# HISTORIC AND DESIGN REVIEW COMMISSION

**HDRC CASE NO:** 2022-346  
**ADDRESS:** 506 STIEREN  
**LEGAL DESCRIPTION:** NCB 2966 (STIEREN STREET REPLAT), BLOCK 1 LOT 18  
**ZONING:** RM-4, H  
**CITY COUNCIL DIST.:** 1  
**DISTRICT:** King William Historic District  
**APPLICANT:** Caroline Gado  
**OWNER:** APOLLO MAYORAL LLC  
**TYPE OF WORK:** New construction of four, multi-story structures  
**APPLICATION RECEIVED:** June 13, 2022  
**60-DAY REVIEW:** Not applicable due to City Council Emergency Orders  
**CASE MANAGER:** Rachel Rettaliata

## REQUEST:

The applicant is requesting conceptual approval to construct four residential structures on the lot addressed 506 Stieren. The proposal includes three, 3-story structures and one, 2-story structure.

**3 UNIT 1-FLOOR PLAN- 3RD LEVEL**  
SCALE: 1/4" = 1'-0"

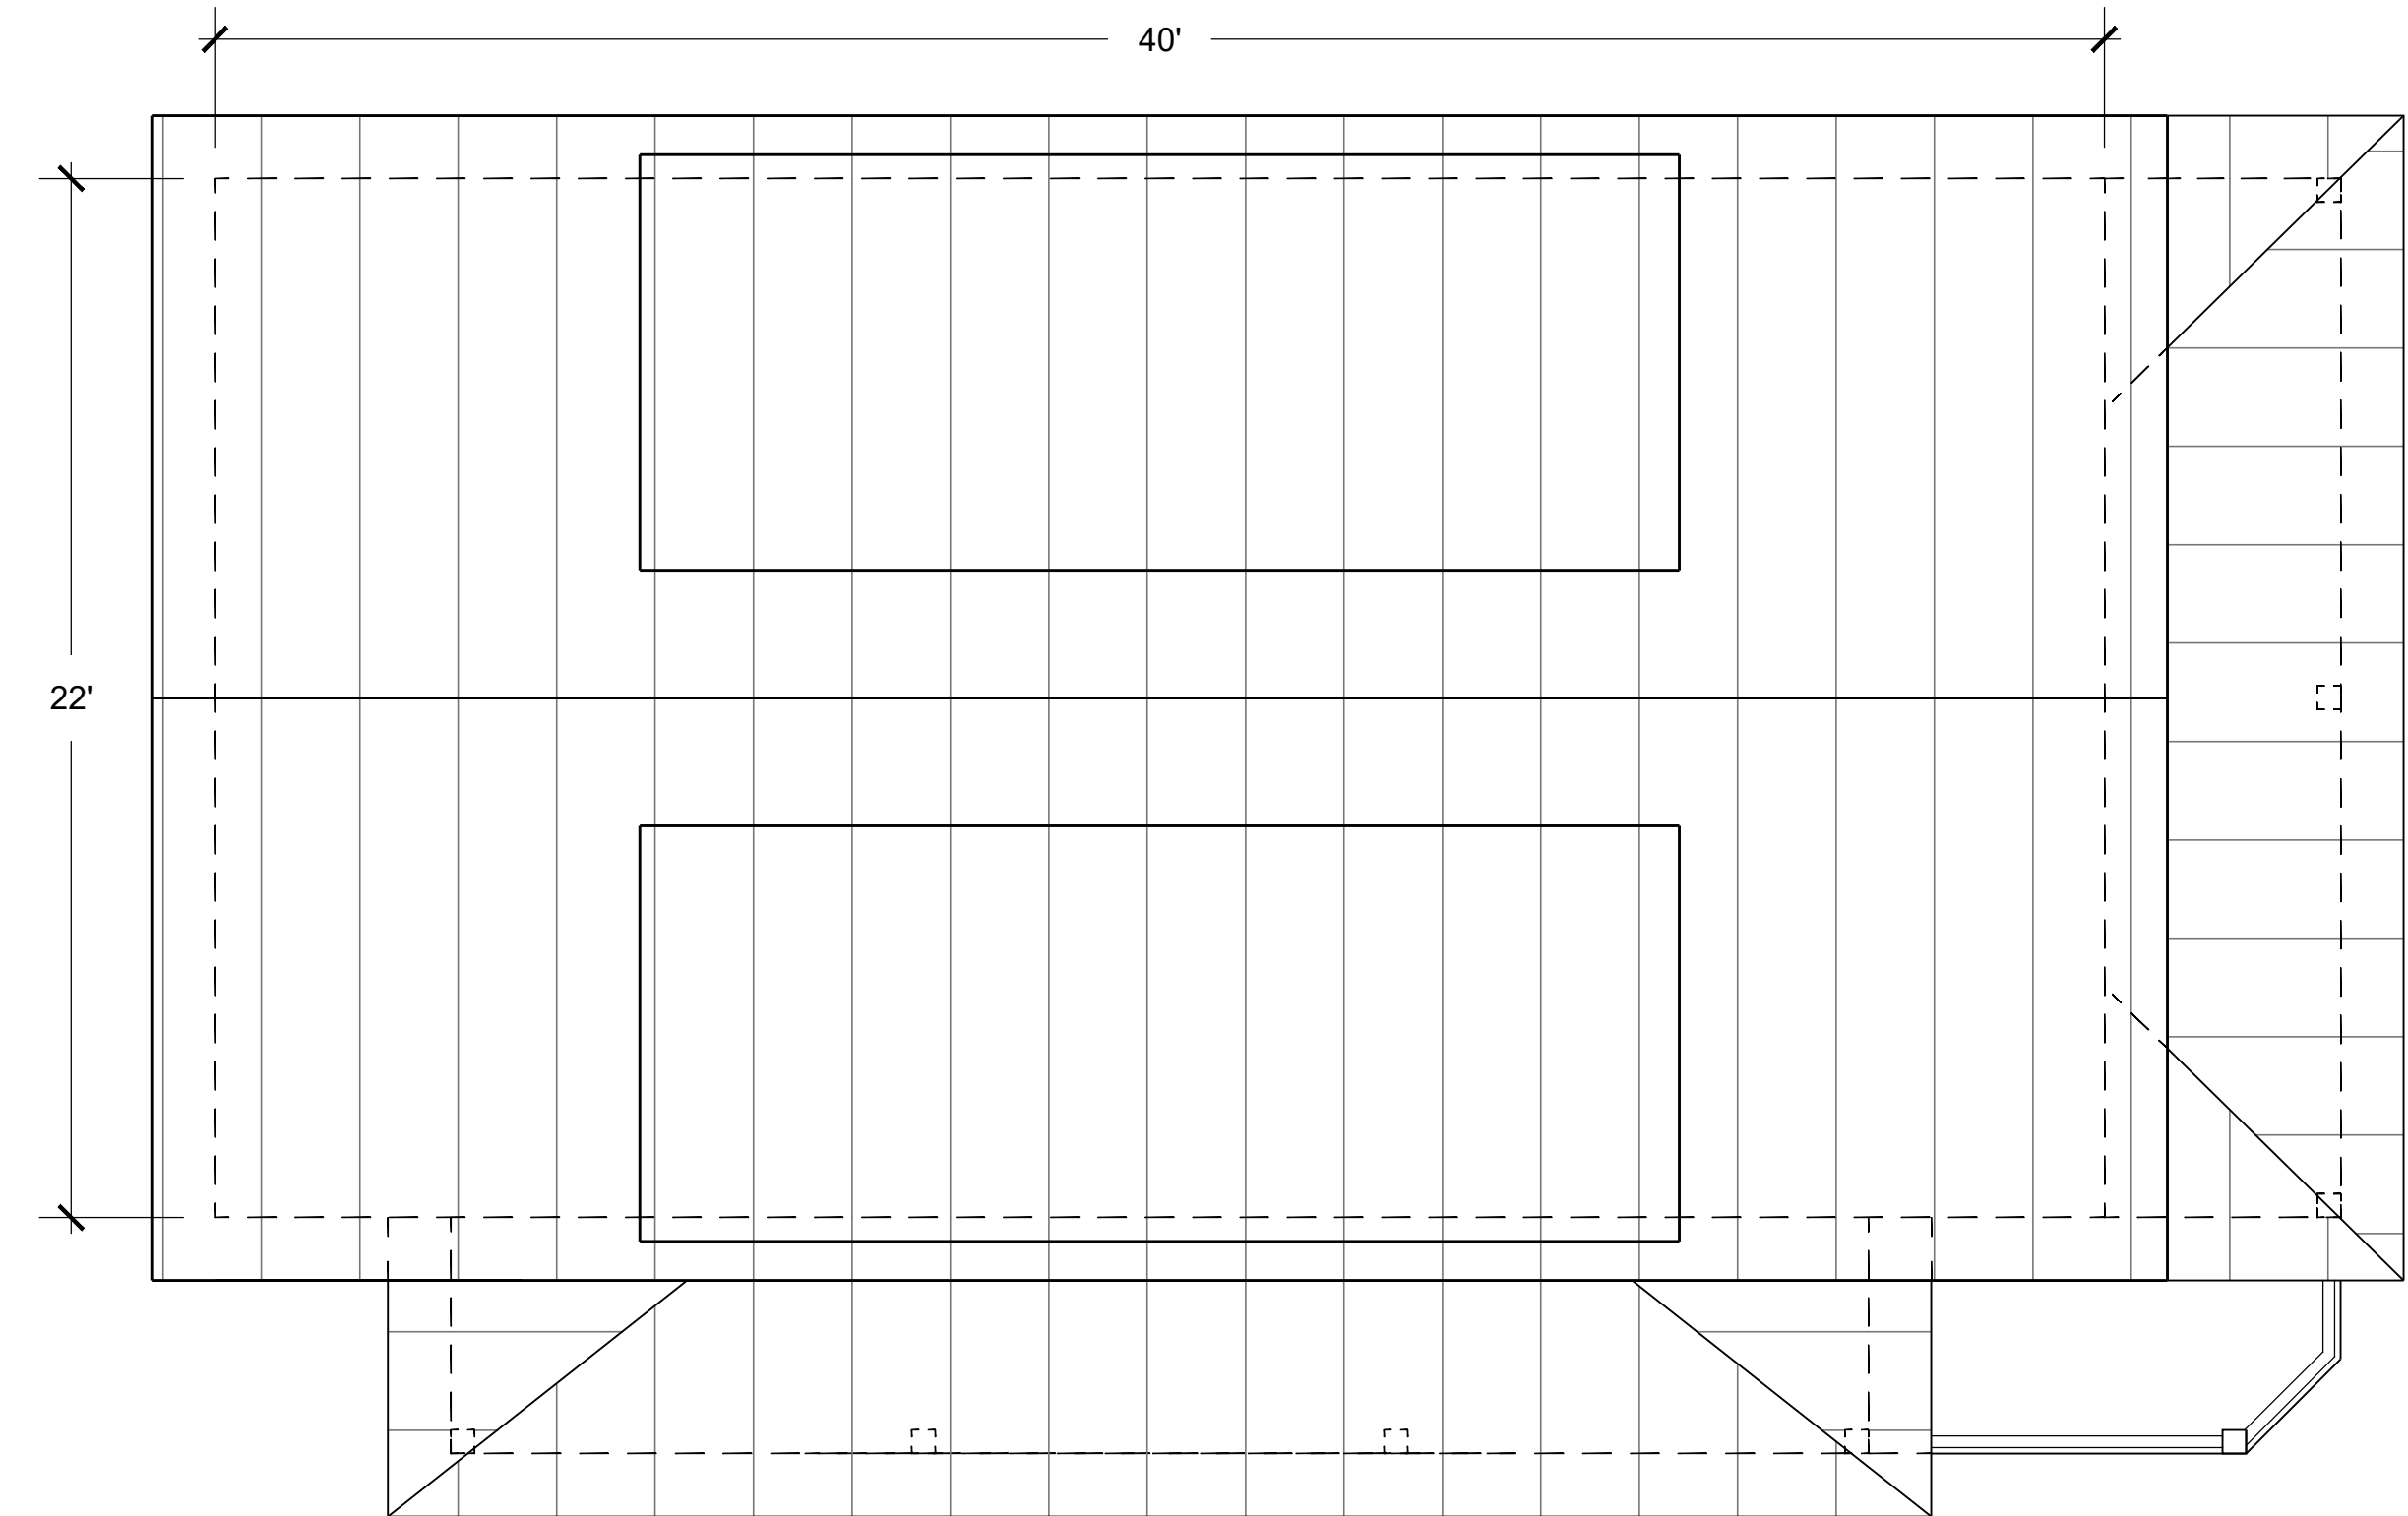
RM: I would like to echo Lisa’s comments. It is awkward having a front door open to a privacy fence.
